**Notice of a Meeting**  
**Dalworthington Gardens Planning and Zoning Commission**

**June 12, 2023 at 6:00 p.m.**

Notice is hereby given that the Dalworthington Gardens Planning and Zoning Commission will hold a public hearing on June 12, 2023 at 6:00 p.m., and the Dalworthington Gardens City Council will hold a public hearing on June 15, 2023 at 7:00 p.m., both of which will be held in the Council Chambers, 2600 Roosevelt Drive, Dalworthington Gardens, Texas to consider the following: A replat application from Vitex Developments, LLC for existing Block 3, Lot 10, changing to Eleanor Estates, Block 1, Lots 1-6, with approximate current addresses being 2601 California Lane and 2615 California Lane, Dalworthington Gardens.

Project Name and Address  
 ELEANOR ESTATES  
 DALWORTHINGTON GARDENS,  
 TEXAS

PROPOSED SITE PLAN

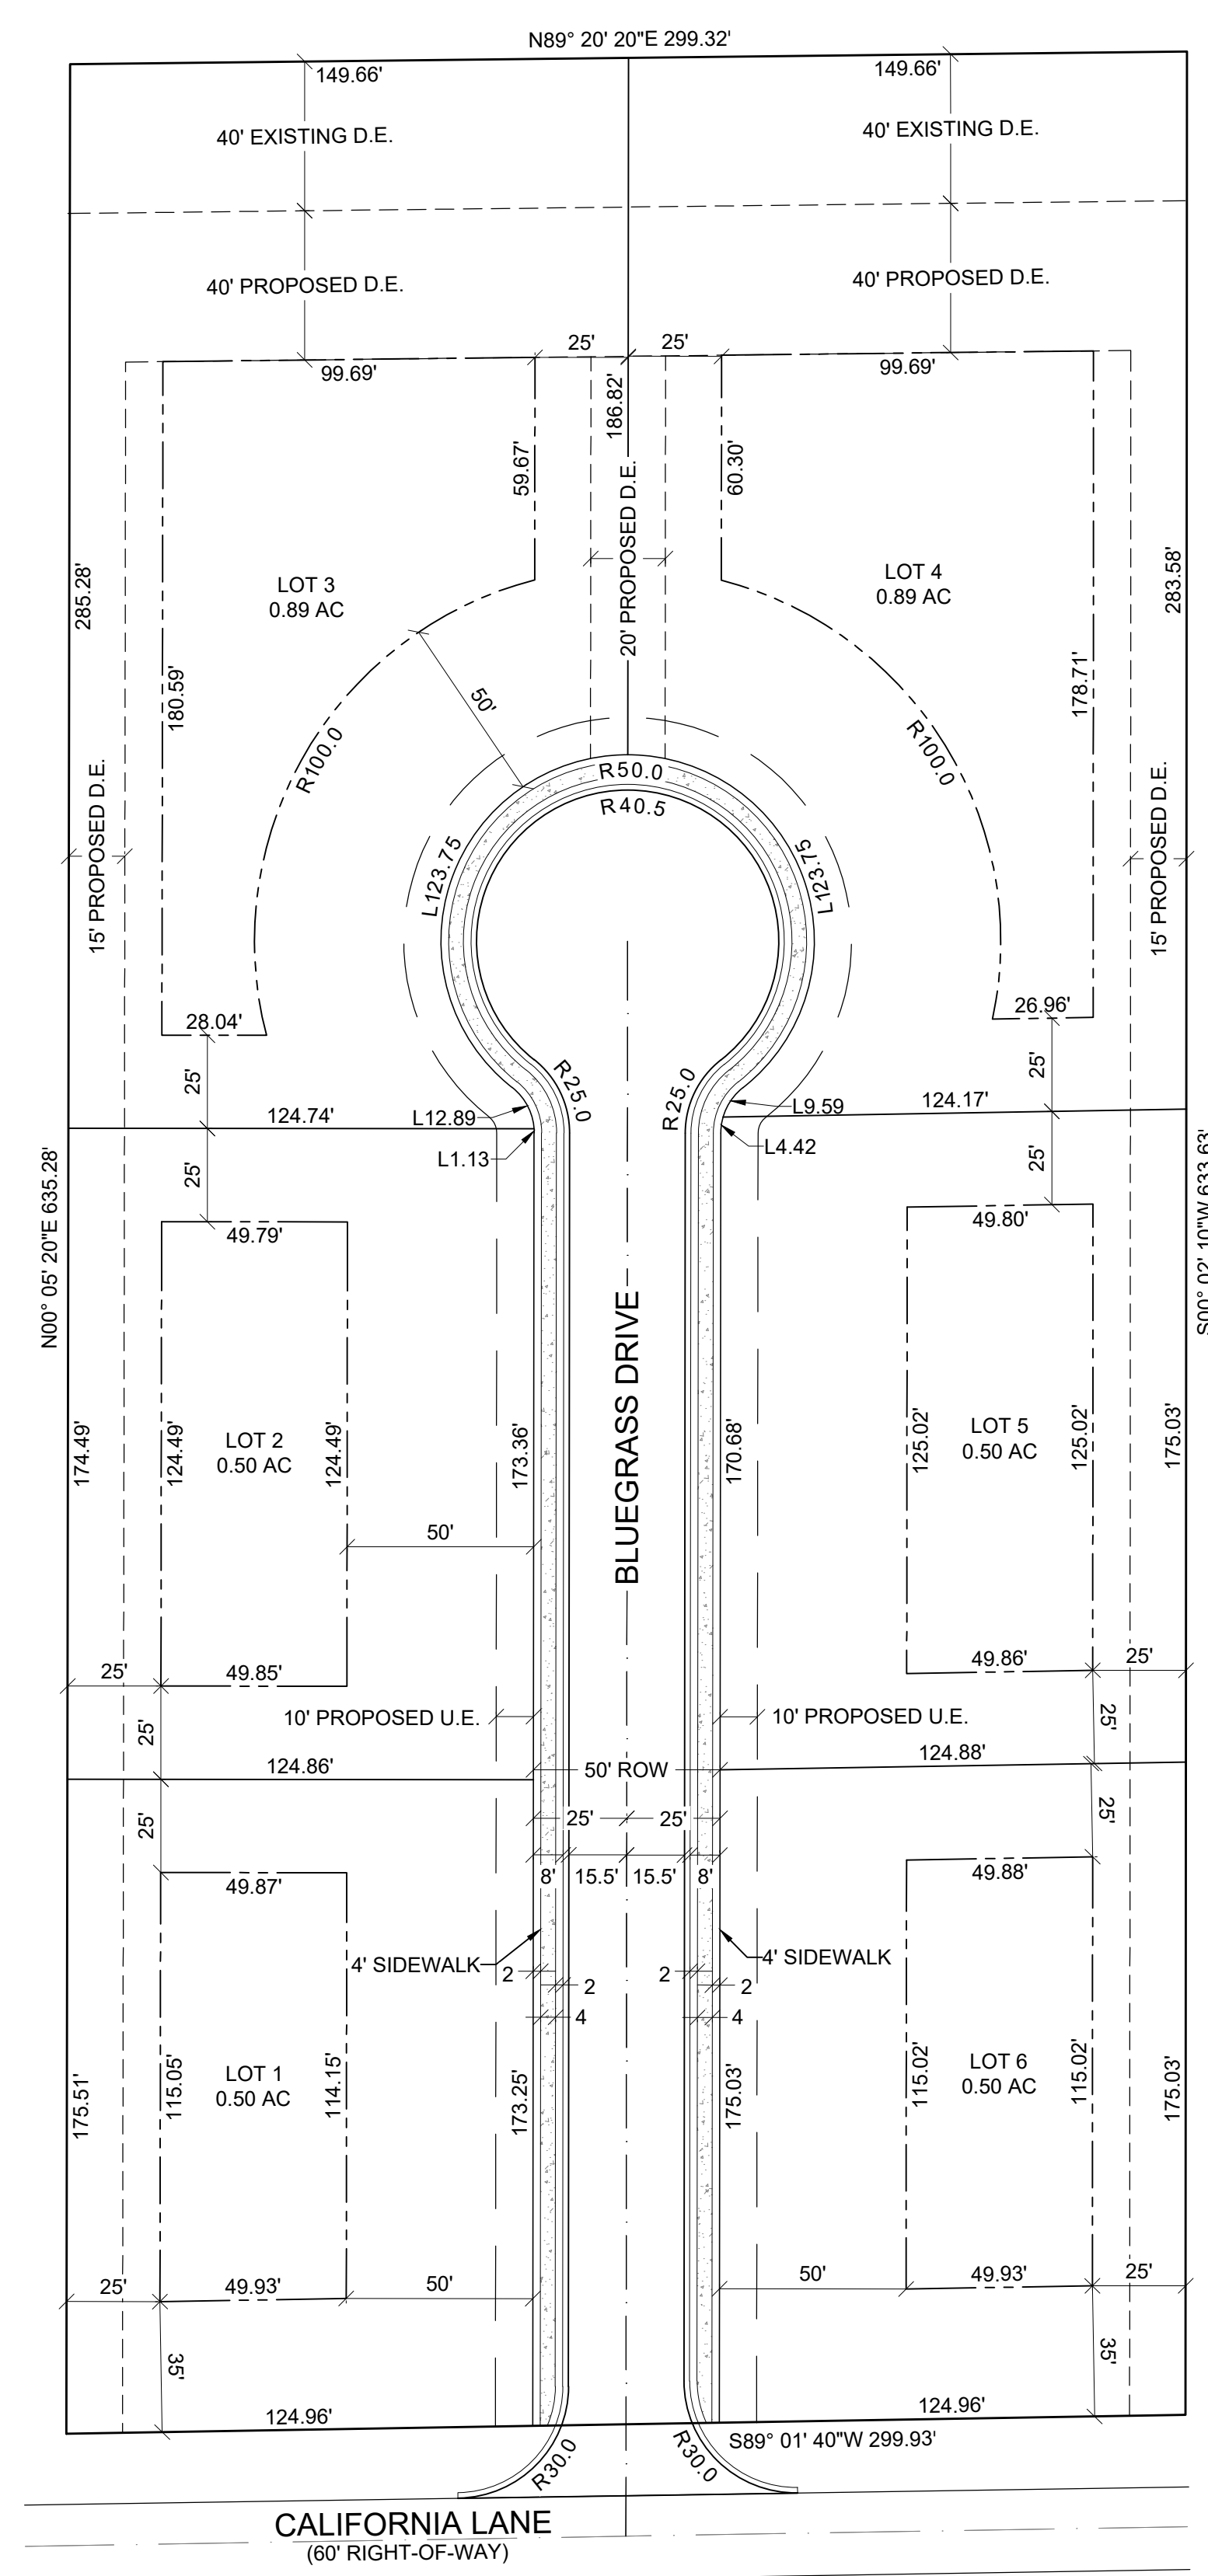
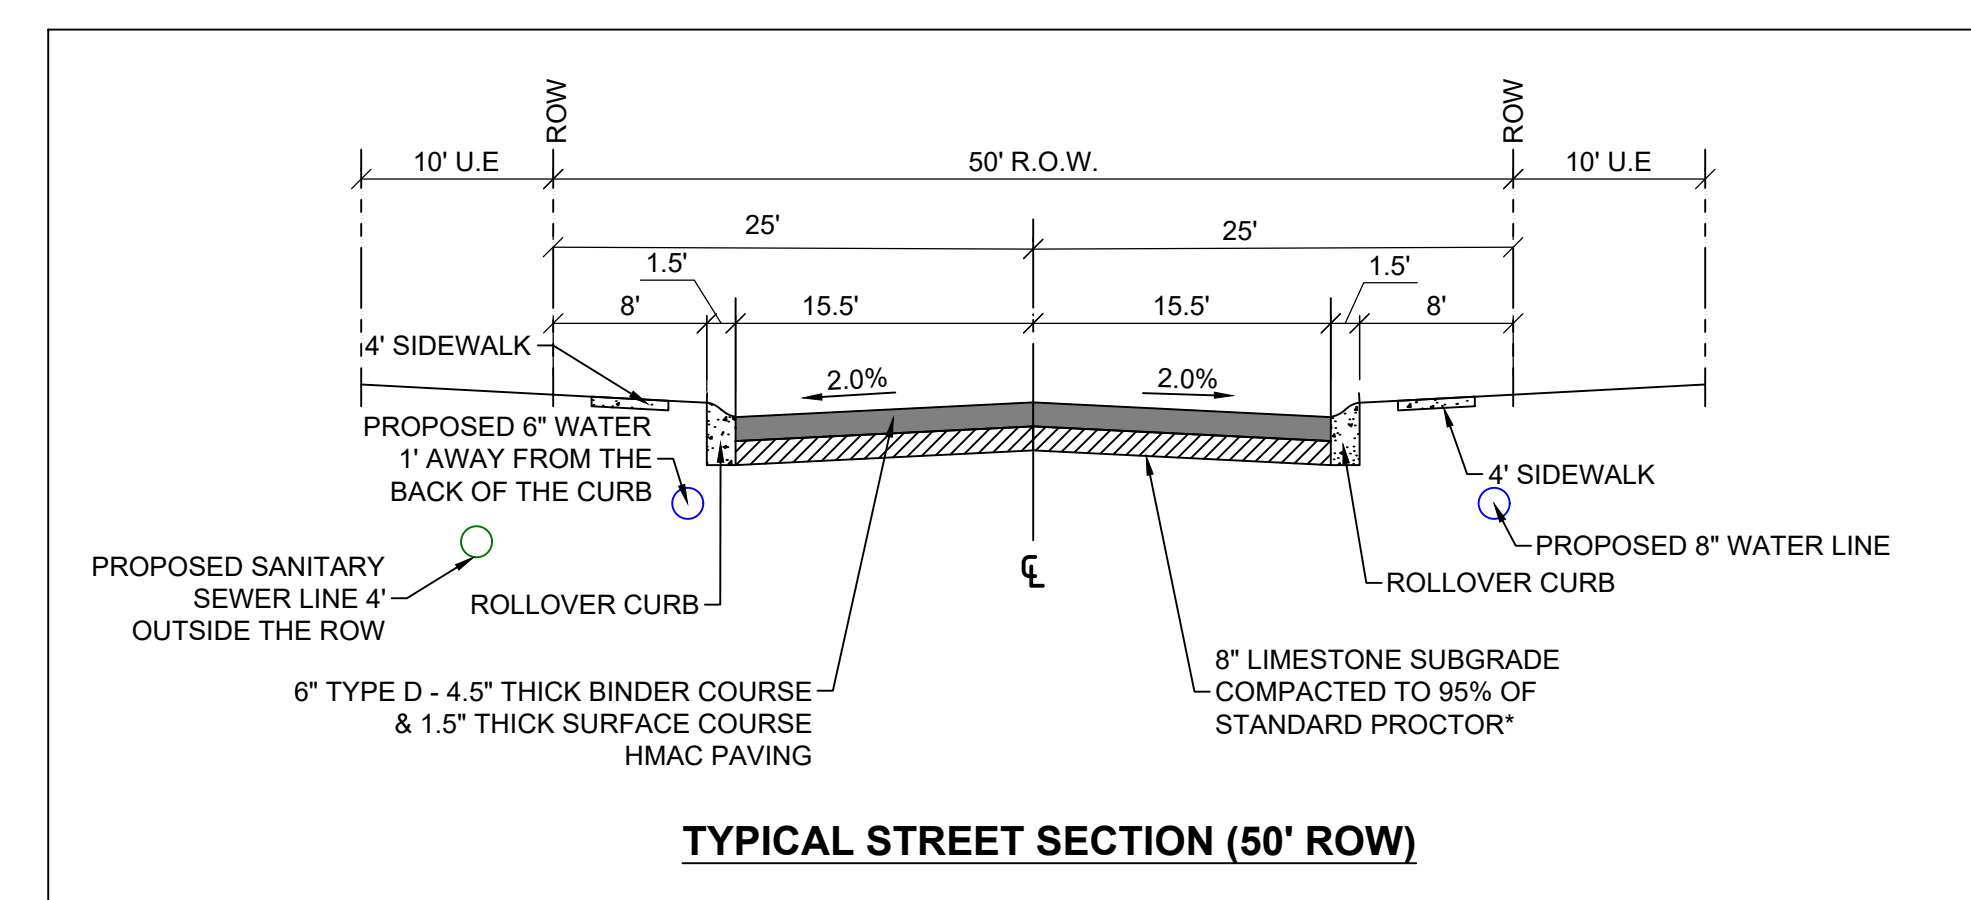
Please show sidewalk on plans when applicable. (typ)

Please show sidewalk

**Response: Sidewalk added to plans and a note also added that home owner/home builder will be installing the sidewalk in front of their property in the street R.O.W** (Completed)

Sidewalk added to plans and a note also added that home owner/home builder will be installing the sidewalk in front of their property in the street R.O.W (Completed)
